# HISTORIC AND DESIGN REVIEW COMMISSION

November 15, 2023

**HDRC CASE NO:** 2023-412  
**ADDRESS:** 501 FURR DR  
**LEGAL DESCRIPTION:** NCB 7012 BLK LOT 1  
**ZONING:** RM-4 CD, H  
**CITY COUNCIL DIST.:** 7  
**DISTRICT:** Monticello Park Historic District  
**APPLICANT:** Jesus Monarez/Charles Todd Helton Architect Inc.  
**OWNER:** Deborah Sands/SANDS DEBORAH  
**TYPE OF WORK:** Demolition of a landmark (accessory), new construction of a detached garage, additions  
**APPLICATION RECEIVED:** September 06, 2023  
**60-DAY REVIEW:** November 5, 2023 (applicant postponed to November 15, 2023)  
**CASE MANAGER:** Jessica Anderson

FRONT ELEVATION

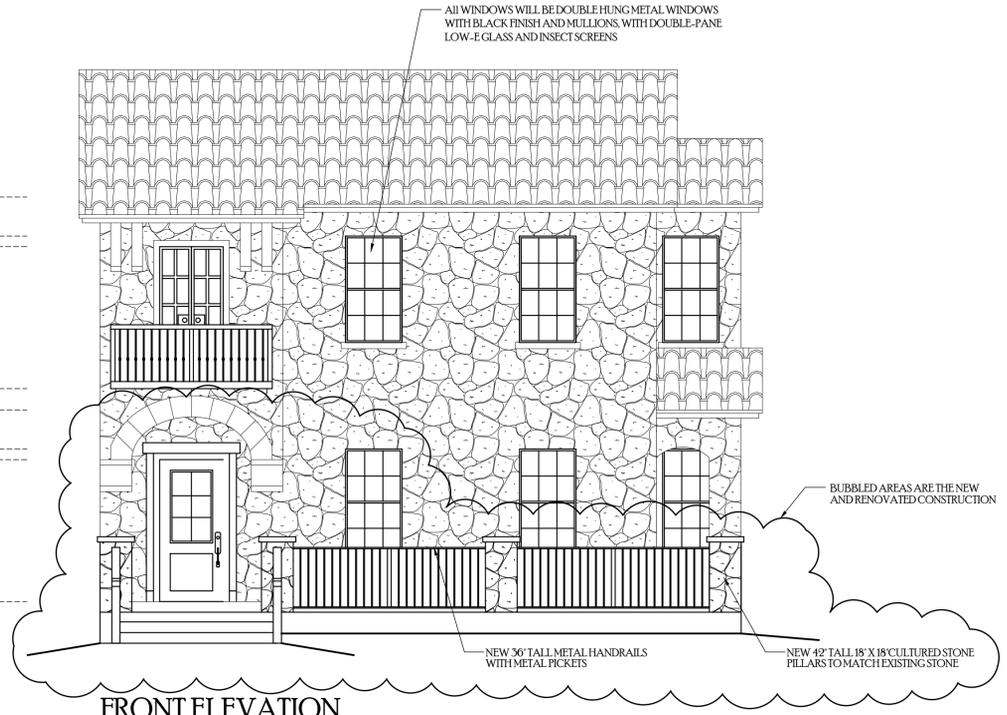
- p. **DOOR REPLACEMENT:** The applicant requests to replace a wood 15-lite door on the second floor of the primary (south) elevation with French doors. Historic Design Guidelines for Exterior Maintenance and Alterations 6.A.ii says to preserve historic doors including hardware, fanlights, sidelights, pilasters, and entablatures. Staff finds the request does not conform to guidelines.

REAR ELEVATION

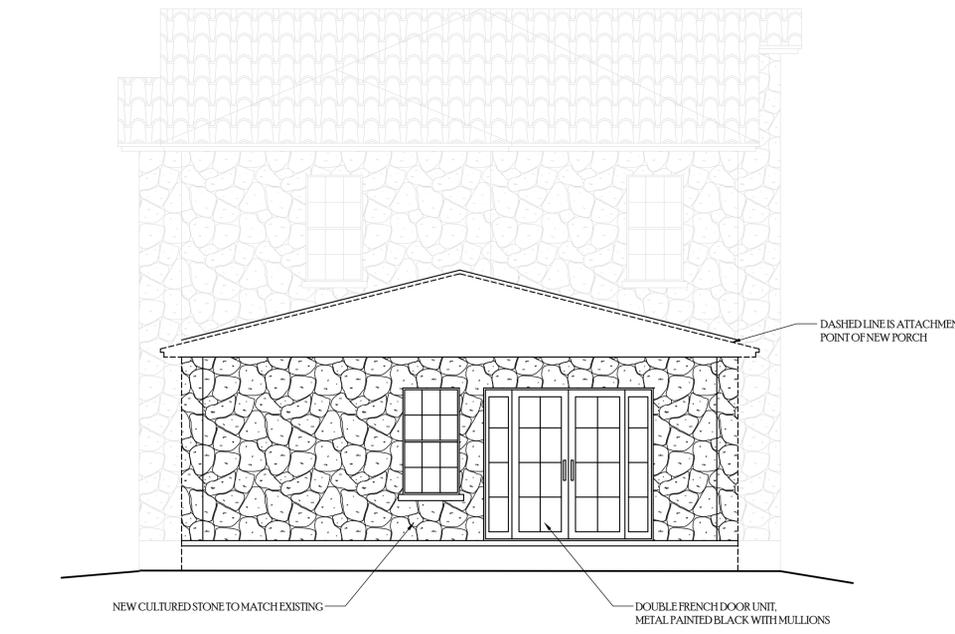
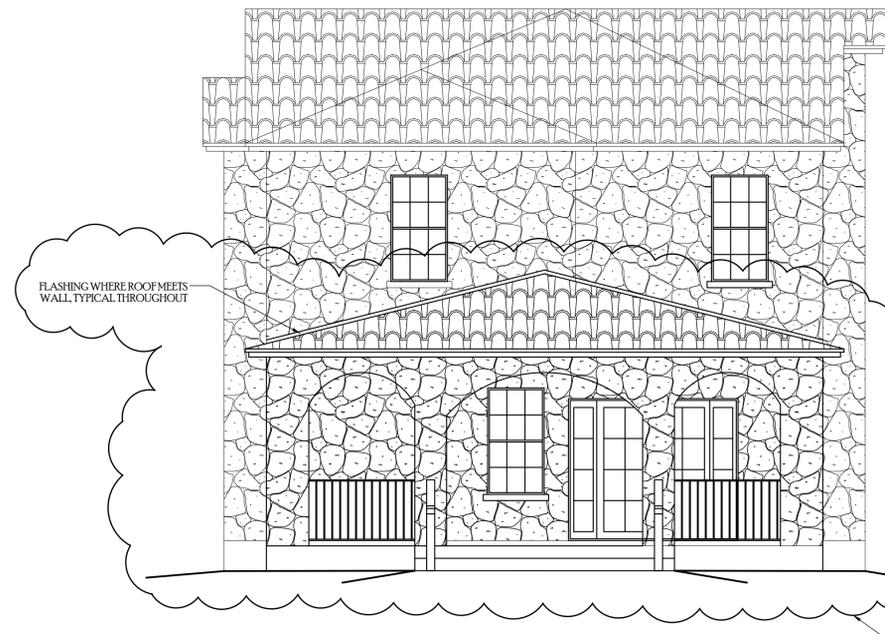
1. **ADDITION (NORTH ELEVATION):** The applicant proposes an approx. 60-square-foot addition to the northwest corner of the first floor of the existing house, inset beneath a proposed covered porch. Modifications to the first-floor exterior of the north elevation include removal of two stoop roofs with barrel tile and knee braces and the doors below, replaced with the continuous roof of the covered porch and metal sliding doors with side lights. The applicant also requests to relocate one window several feet to the left. Historic Design Guidelines for Exterior Maintenance and Alterations 6.A say to preserve historic windows and openings Historic Design Guidelines for Additions 4.B.i says to design additions to reflect their time while respecting the historic context. Consider character-defining features and details of the original structure in the design of additions. These architectural details include roof form, porches, porticos, cornices, lintels, arches, quoins, chimneys, projecting bays, and the shapes of window and door openings. Staff finds the proposed addition conforming, but that the applicant should propose a product for the sliding doors in keeping with the material, style, and period of construction of the home. Staff finds the request to relocate the first-floor window does not conform to guidelines.

- i. That the applicant proposes a sliding door product in keeping with the material, style, and period of construction of the home, namely one made of wood and without false muntins or side lites.
- ii. That the window on the first floor of the north elevation is retained in place.

THE SANDS RENOVATION  
 GARAGE FLOOR PLAN, 1/4" = 1'-0"  
 CHARLES TODD HELTON ARCHITECT, INC.  
 281.528.8181  
 www.charlestoddhelton.com

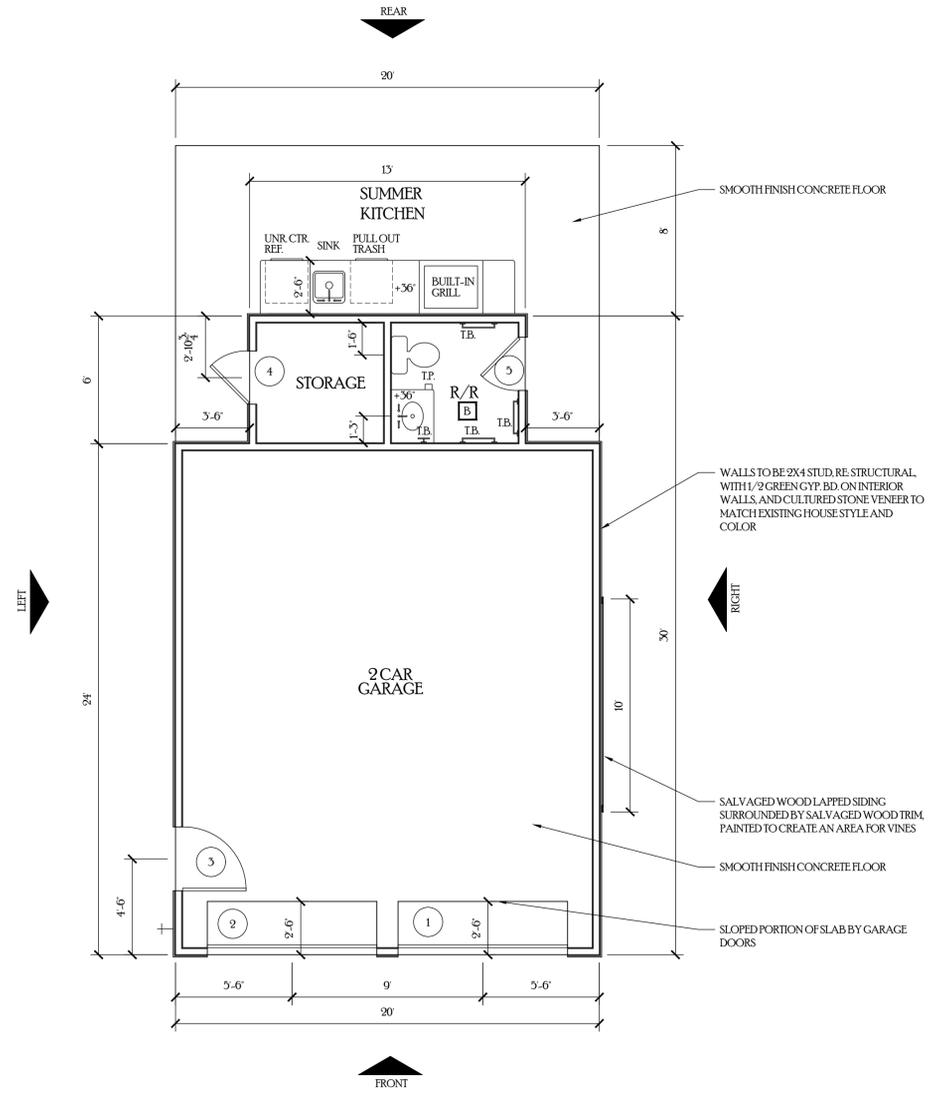
- i. **NEW CONSTRUCTION OF DETACHED GARAGE:** The applicant proposes to replace the existing garage with a 610-square-foot detached two-car garage. The garage features split-bay garage doors, stucco and salvaged wood cladding, and a barrel tile roof to match the primary structure. An open-air kitchen is included under the primary roof form of the garage, contributing to the overall square footage. The garage has one pedestrian door on the north elevation and two pedestrian doors on the south elevation. The applicant also did not provide a full list of materials or manufacturer's specifications for the proposed garage door and pedestrian doors. The Guidelines for New Construction 5.A. notes that new garages and outbuildings should be visually subordinate to the primary historic structure in terms of their height, massing, and form, and should be no larger in plan than forty percent of the primary historic structure's footprint. The existing two-story primary structure on the lot features a footprint of 1,254 square feet. The proposed one-story accessory structures feature a total footprint of 610 square feet, or approximately 49% of the primary structure's footprint. The neighborhood features predominately single-story accessory structures, but there are some examples of two-story accessories. Staff finds the footprint of the proposed garage does not conform to historic design guidelines.
